RECEIPT DATE: 1/8/19 **ONSITE SEWAGE DISPOSAL SYSTEM** P 564713
 APPROVAL DATE: 02/15/2019 **PERMIT: CONSTRUCTION** A _____
 PROPERTY ADDRESS: 12414 All Daughters Lane
 SUBDIVISION: Orchard Estates LOT: 5 TAX ID: _____
 CONTRACTOR: Hatfield's Equipment EMAIL: ken@hatfieldsequipment.com
 CONTRACTOR ADDRESS: P.O. Box 419 Annapolis Junction, MD 21701 PHONE: 301-490-4289
 PROPERTY OWNER: MB Orchard Estates EMAIL: _____
 OWNER ADDRESS: 1686 E. Gude Drive, Rockville, MD PHONE: 301-762-9511
 SEPTIC TANK SIZE (GALLONS): 2000 TANK MANUFACTURER: Babylon
 PUMP MODEL: _____ PUMP SIZE _____ PUMP TANK CAPACITY: _____

LETTER OF TRANSMITTAL

DATE	10-24-2018	JOB NO.	15112
PROJECT	Orchard Estates		
	Lot 5 (12414 All Daughters Lane)

ONSITE SEWAGE DISPOSAL SYSTEM DESIGN PLAN

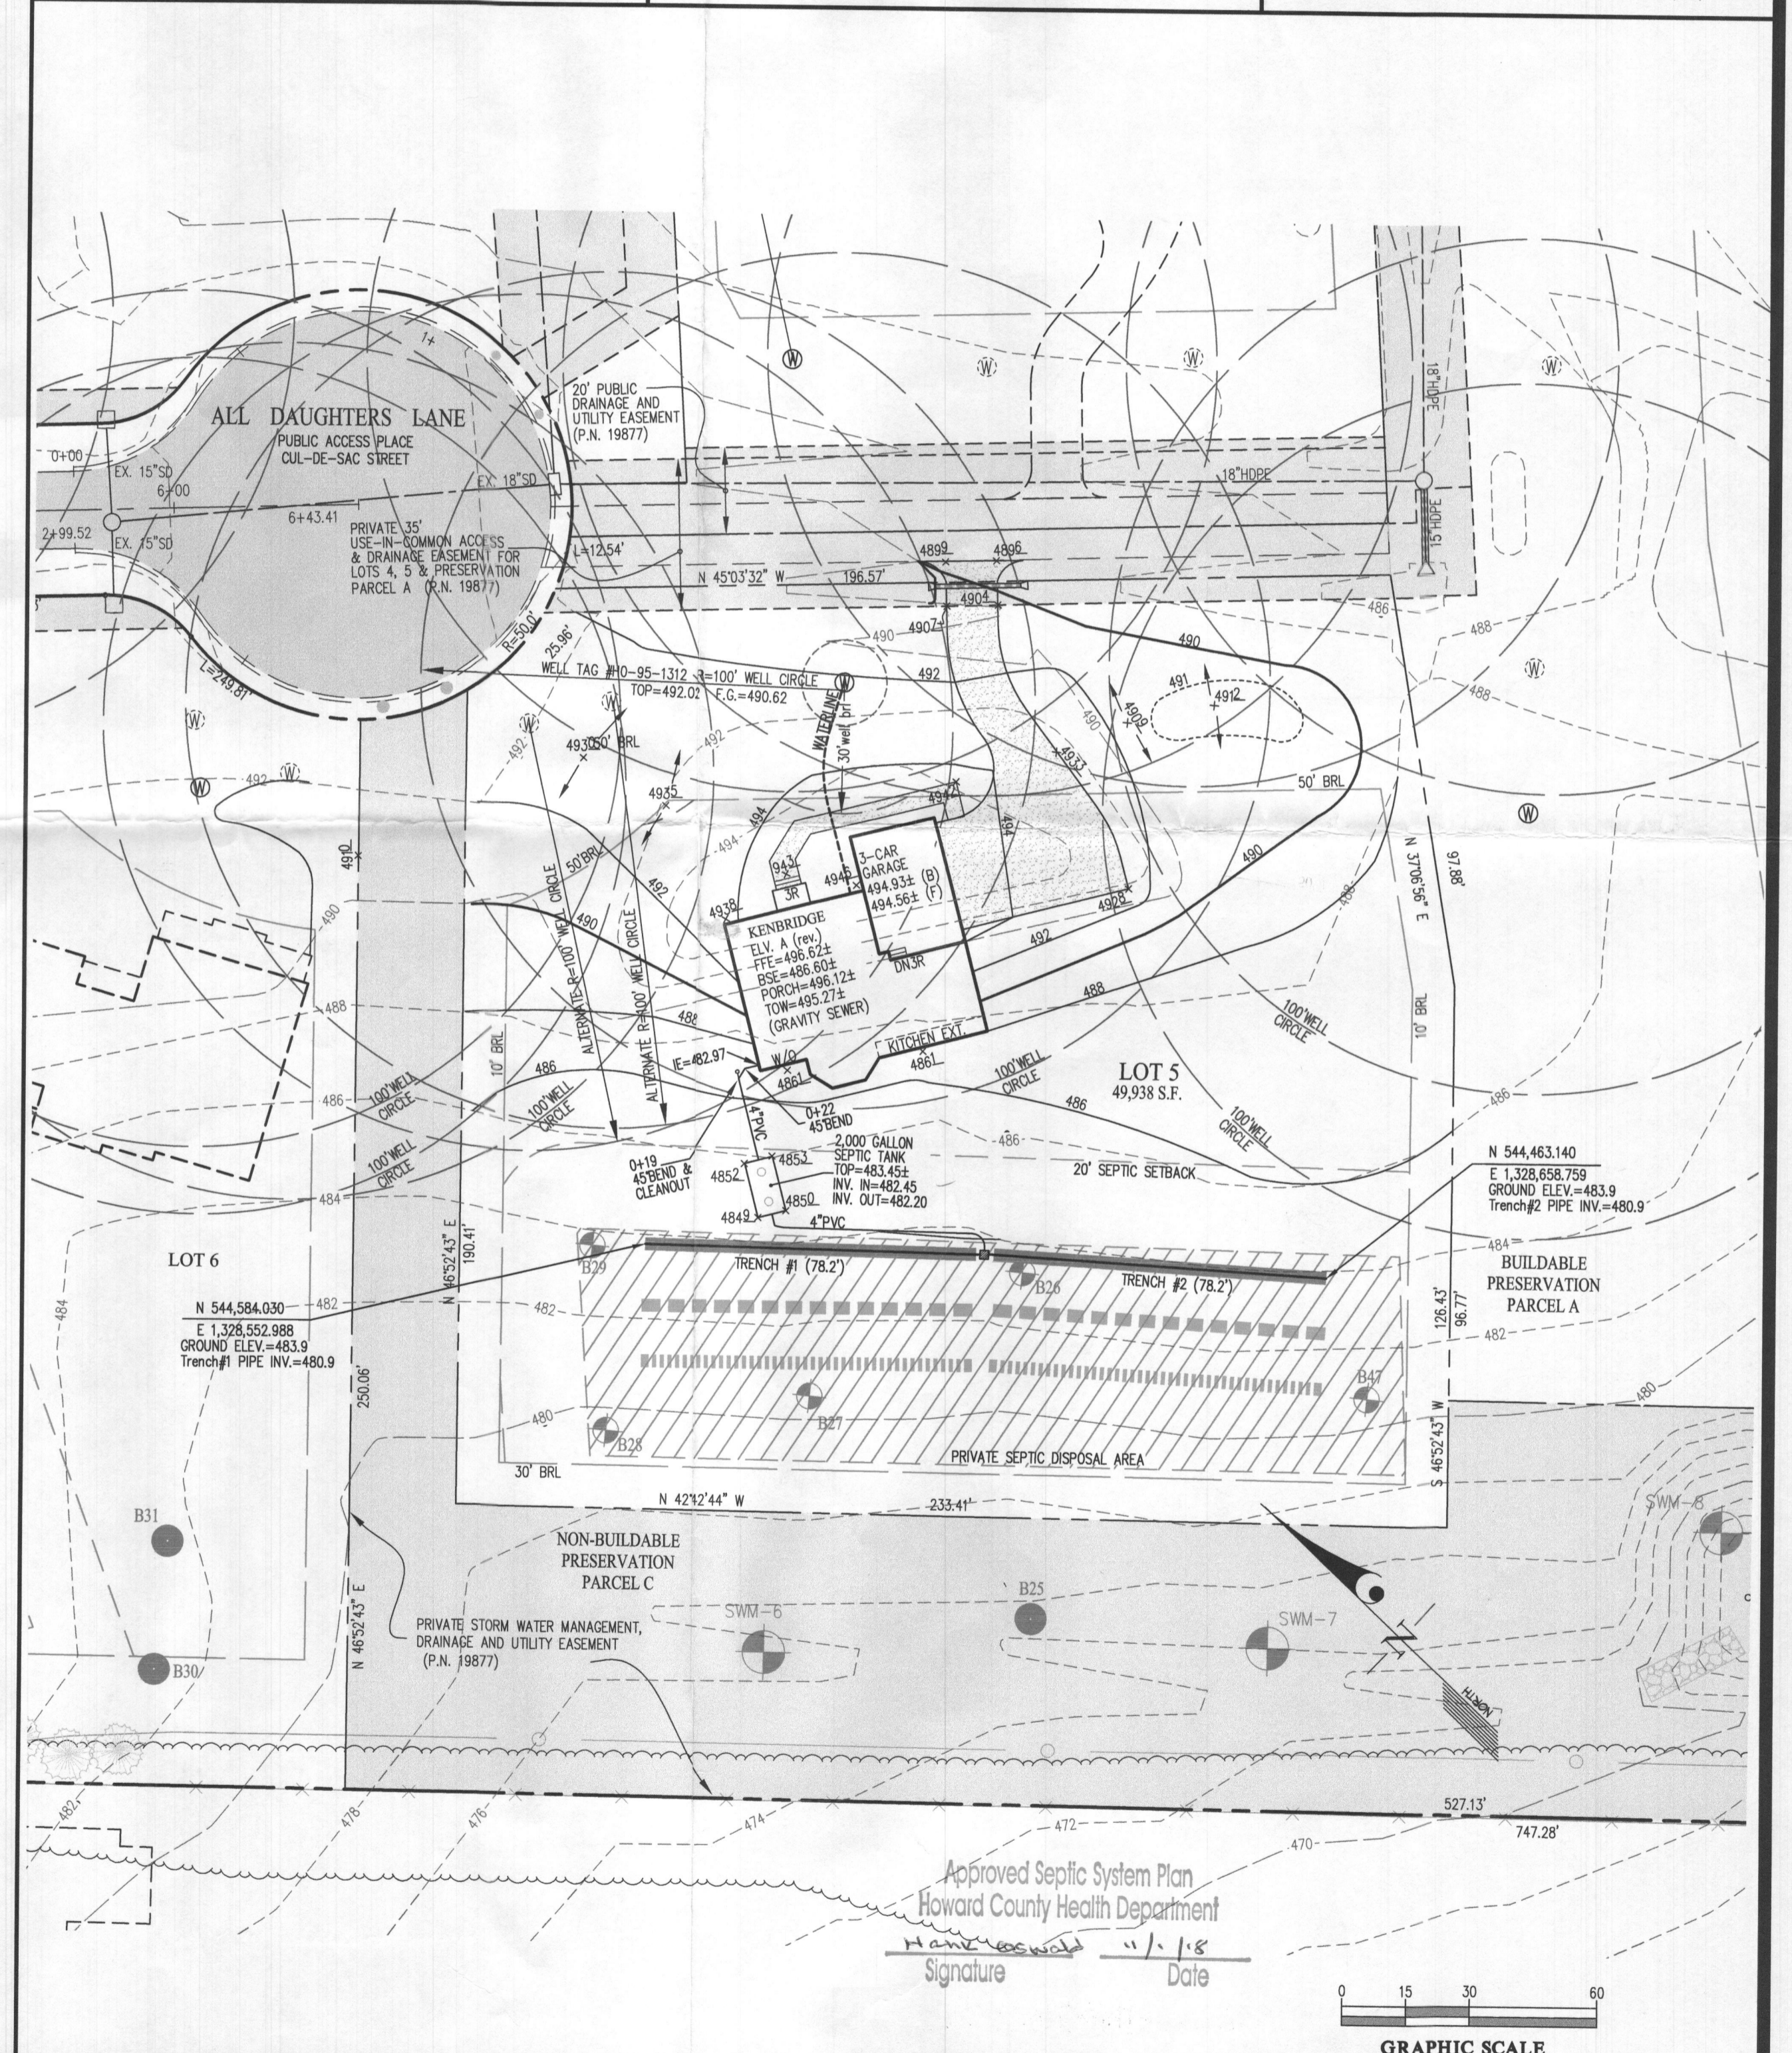
REMARKS: Hi Hank,
Here is the updated OSDS plan for Lot 5 for review showing the septic tank slid over because the homebuyers would like the tank further away from their future pool/patio area.
